# TECHNICAL SERVICE BULLETIN

## 2.7L/3.0L EcoBoost - Oil Pan Leaking

**23-2338**

This article supersedes TSB 22-2181 to update the Service Procedure and Part List.

Figure 1

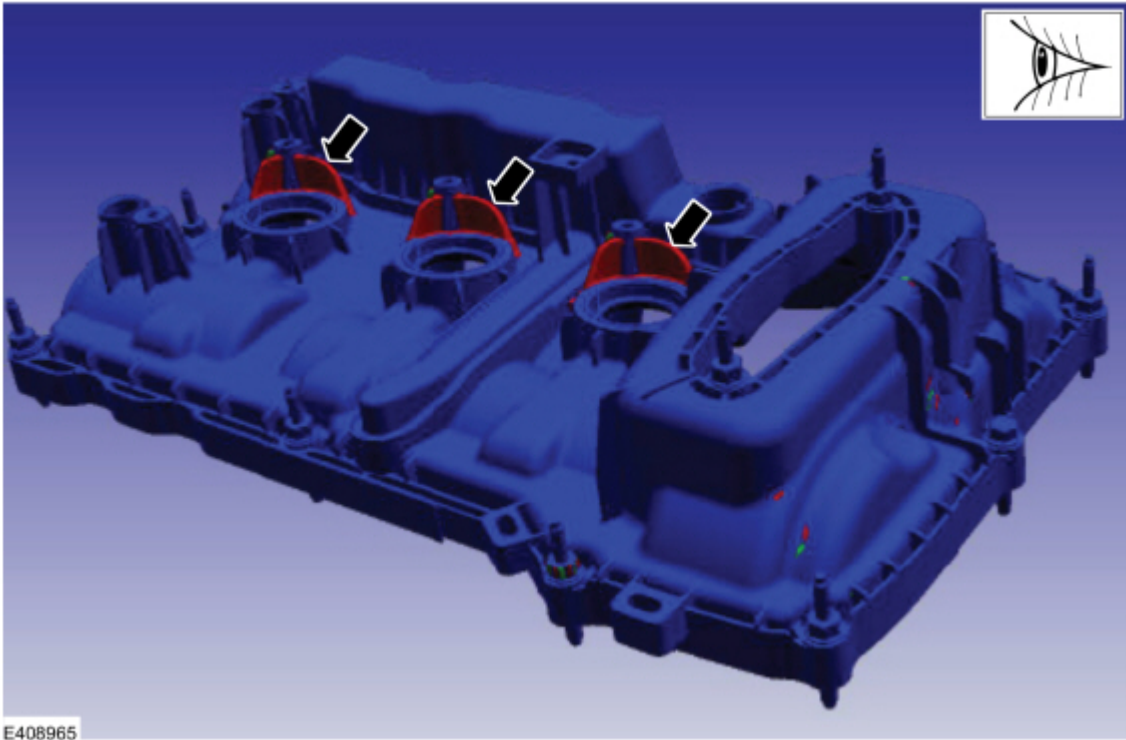
1. Inspect the valve cover design around the ignition coils on both sides. Does the coil location have the extended plastic protective ribbing as shown in red? (Figure 1)

(1). Yes - proceed to Step 3.

(2). No - proceed to Step 2.

2. Replace both valve covers. Refer to Workshop Manual (WSM), Section 303-01, Removal and Installation > Valve Cover LH and Valve Cover RH. Proceed to Step 3.
3. Remove and discard the oil pan and oil pump seal. Refer to WSM, Section 303-01, Removal and Installation > Oil Pan.
4. Clean and prepare the engine sealing surface. Refer to WSM, Section 303-00 General Procedures.
5. Install the new oil pump seal. Refer to WSM, Section 303-01, Removal and Installation > Oil Pan.
6. Apply a 18 mm (0.708 in.) bead of Motorcraft® High Performance Engine RTV Silicone to the oil pan where the front cover-to-cylinder block joint areas contact. (Figure 2)
